March 8, 2024

TO: Saint Paul Planning Commission

SUBJECT: Bicycle Plan Update | Transportation Committee resolution re: Maryland Avenue, Johnson Pkwy to Ruth St

Figure 3. February 2024 planned network does not include a separated bikeway on Maryland

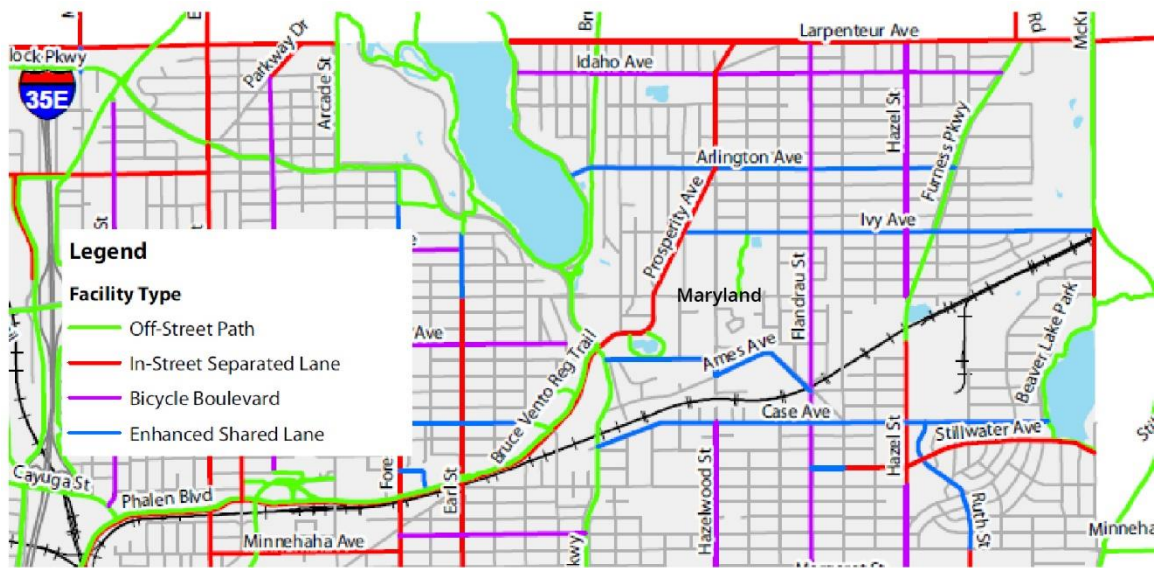
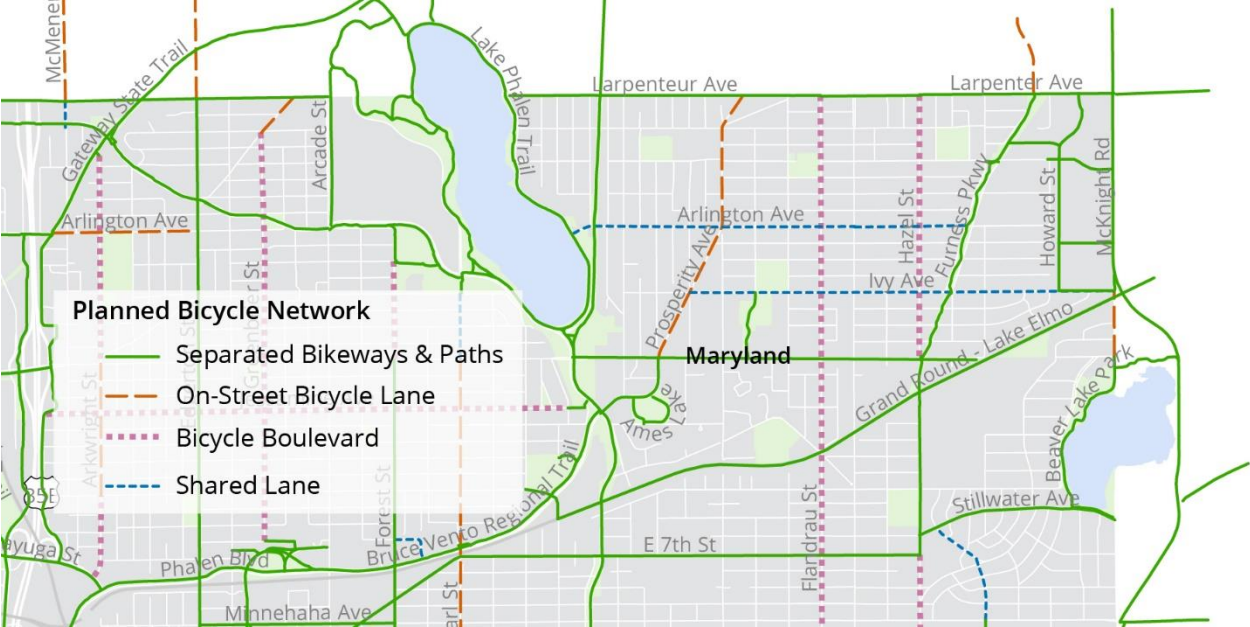
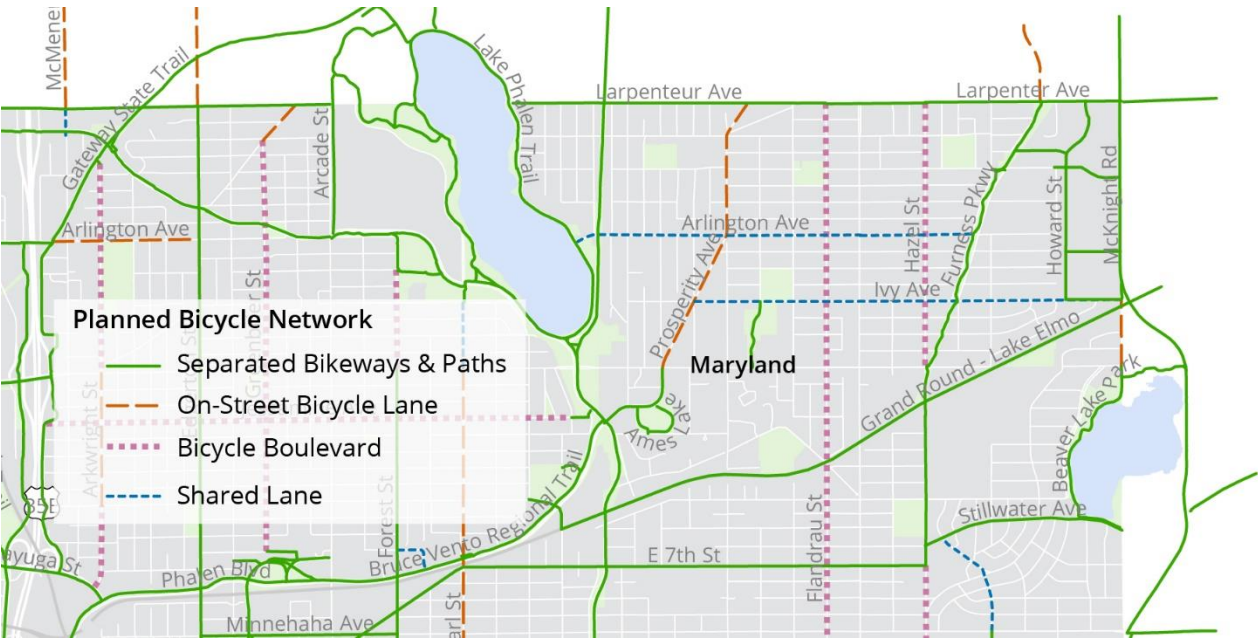
As recently as the December 2023 draft of the updated Bicycle Plan, a section of Maryland Avenue between Johnson Parkway and Ruth Street was identified for a planned separated bikeway (Figure 2). Based on feedback from the Public Hearing on February 2, and after discussions with Ramsey County and the Purple Line BRT design team, staff recommended prioritizing the limited space on Maryland for future transit. As a result, the February 2024 revision to the draft planned bicycle network *did not* recommend adding a separated bikeway on this segment of Maryland (Figure 3). Ultimately, the February 2024 planned bicycle network represents no change in recommendations from the current Bicycle Plan (adopted 2015).

Planned Bicycle Network

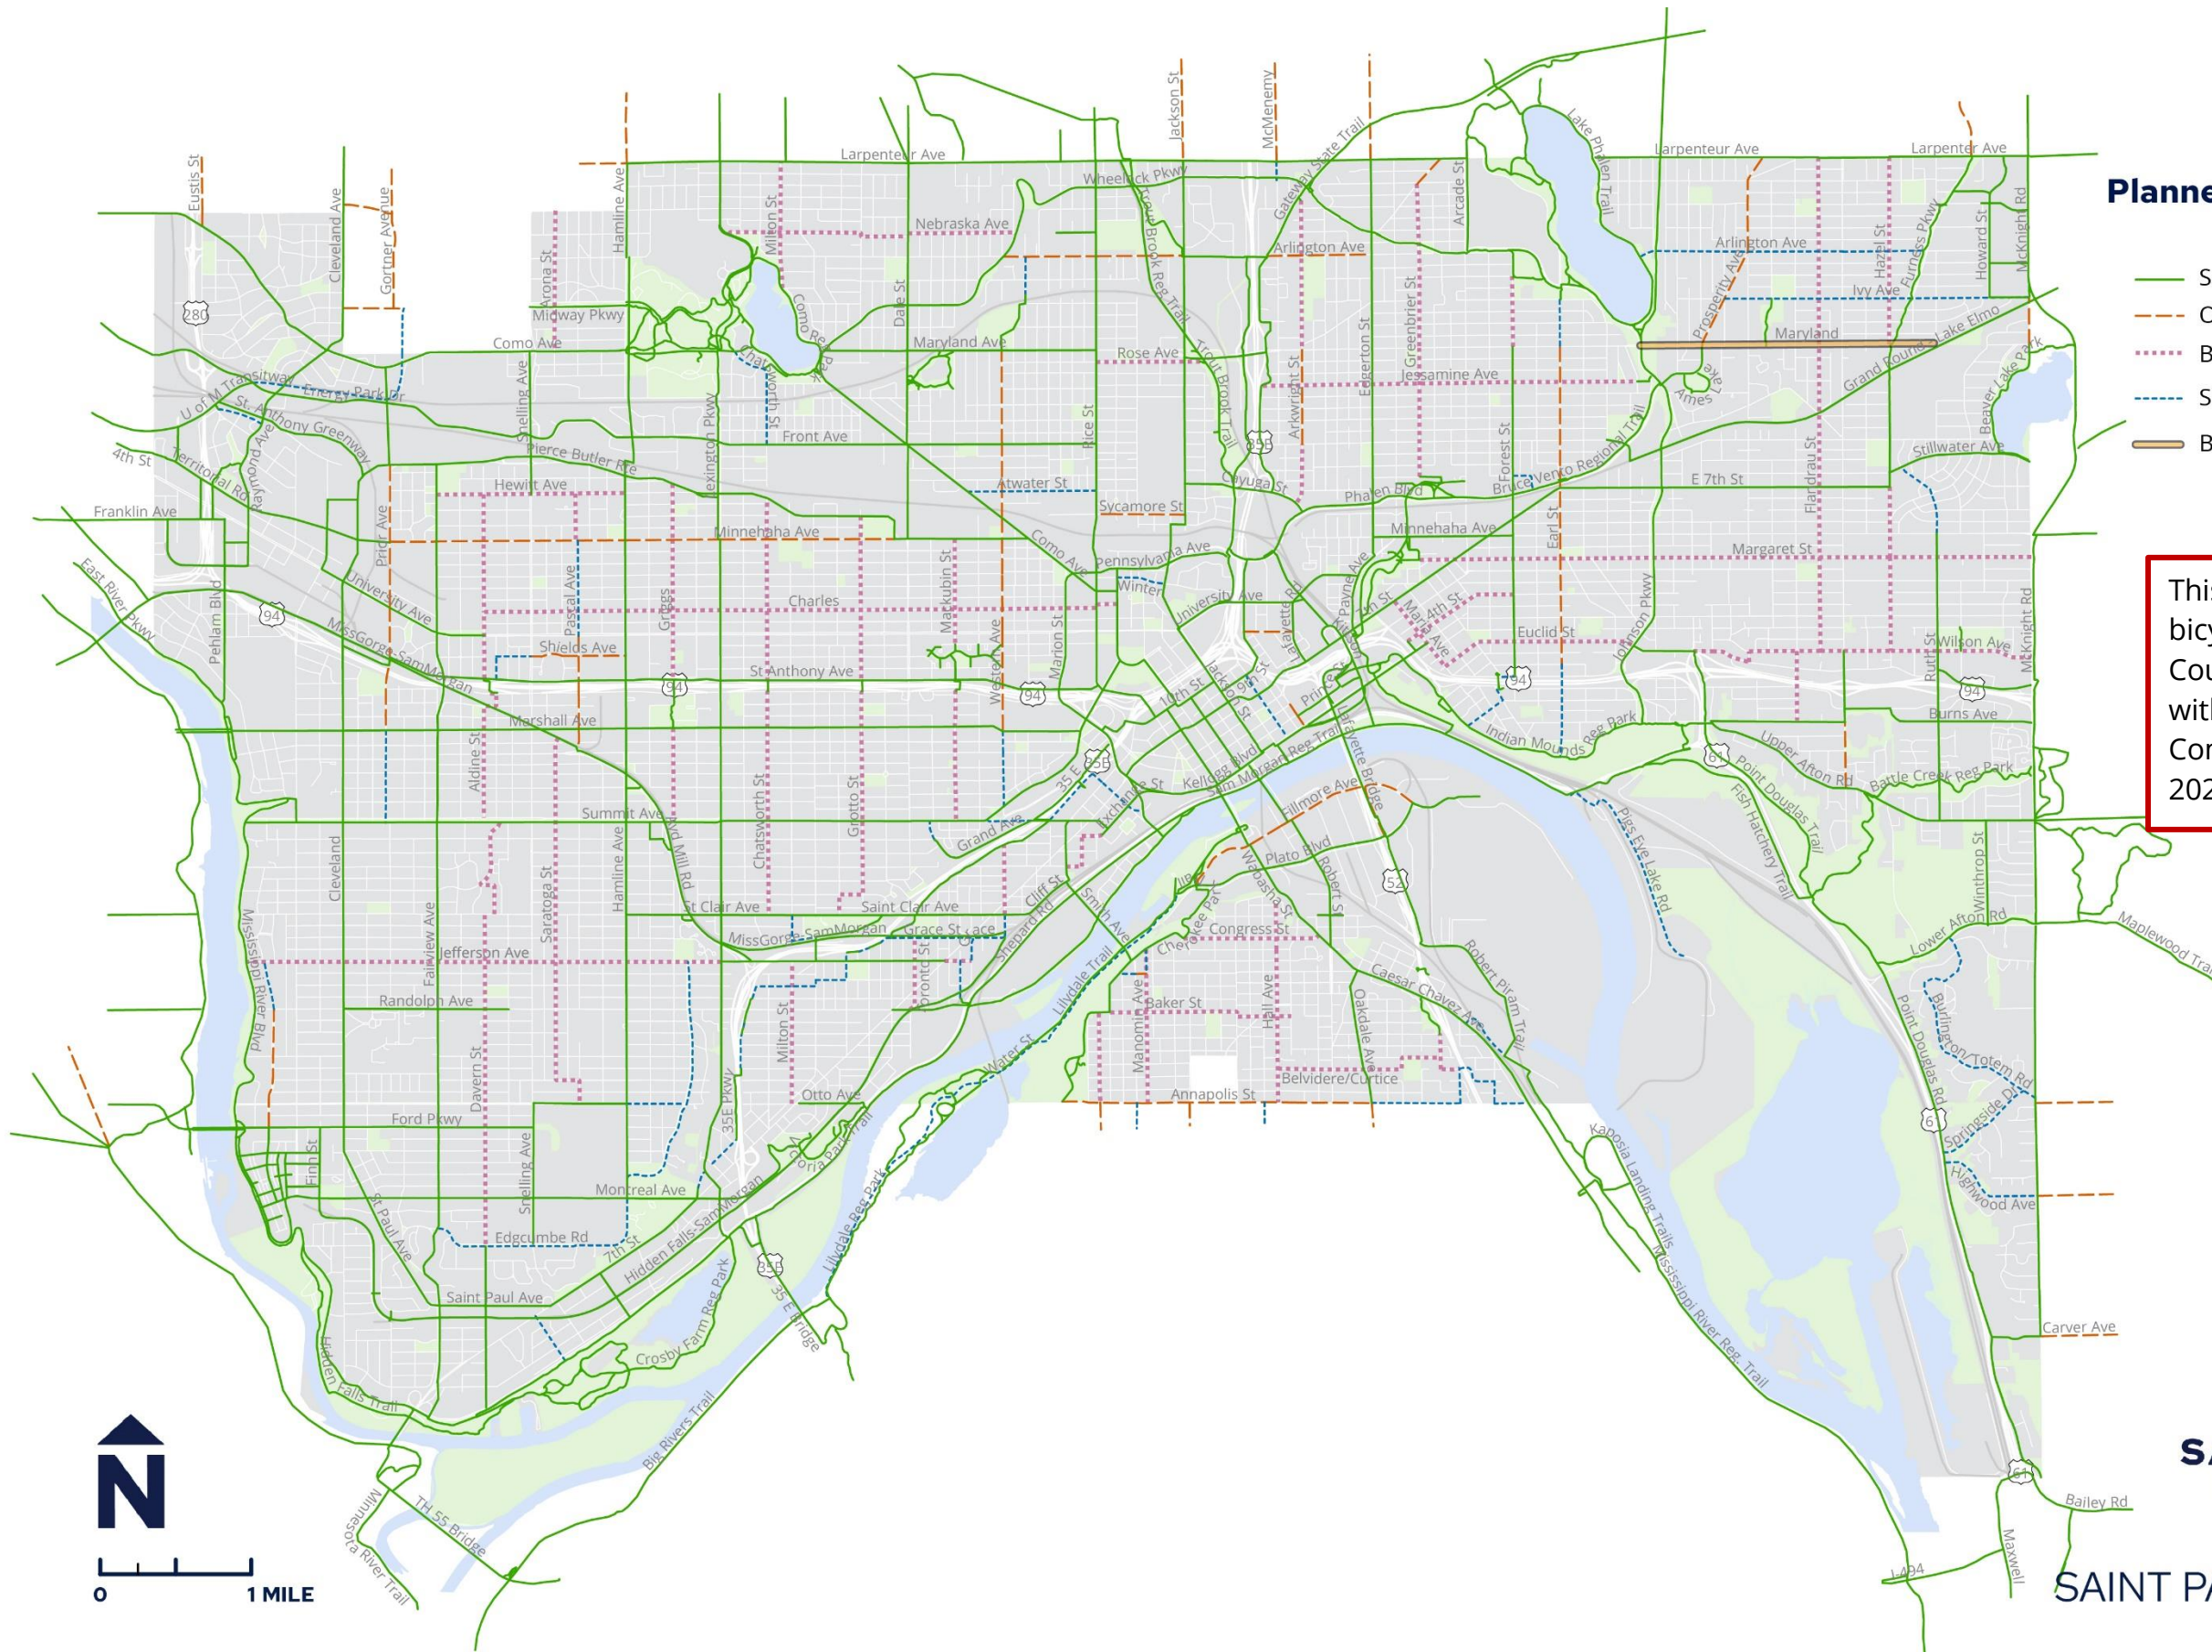
- 1. A new line be added to the Planned Bicycle Network map on Maryland Avenue east of Johnson Parkway to Ruth Street, in a manner that recognizes and prioritizes transit planning processes in that segment; and**

- On the Planned Bicycle Network map, a line on Maryland would be added between Johnson Pkwy and Ruth St. The corresponding line in the map legend would read "bikeway for further study". This would be the only such line on the planned network map. There are several additional maps in the Plan that show the planned bicycle network. This same section of Maryland would be included in all the maps featuring the planned network. Please see the map attached at the end of this document.
- In the Plan document, this section of Maryland would be acknowledged as unique and called out specifically. Language would be added on page 52 of the Plan dated February 23, 2024 that reads:

Maryland Avenue between Johnson Parkway and Ruth Street is shown in the planned bicycle network as "bikeway for further study". Currently, a portion of this section of Maryland between Johnson and White Bear Avenue is being considered for future high frequency transit service by the Purple Line Bus Rapid Transit (BRT) and H Line Arterial BRT. At the time of adoption of this Bicycle Plan, it is not known what the future of design will look like for this portion of Maryland, if and how space for people biking can be accommodated, and the timing of implementation of any future designs. Future coordination is needed between the City, Metro Transit, and Ramsey County, the agency who owns and designs Maryland between Johnson and White Bear Avenue.

Public Works staff have reviewed the updated resolution recommended by the Transportation Committee on February 26. After consideration, staff commits to the recommendation that the portion of Maryland Ave between Johnson Pkwy and Ruth St NOT include a planned bikeway of any kind. Right-of-way space along this portion of Maryland is highly constrained, and a high quality bikeway (one that meets best practices and includes separation) would be difficult to accommodate with other uses being considered on the corridor.
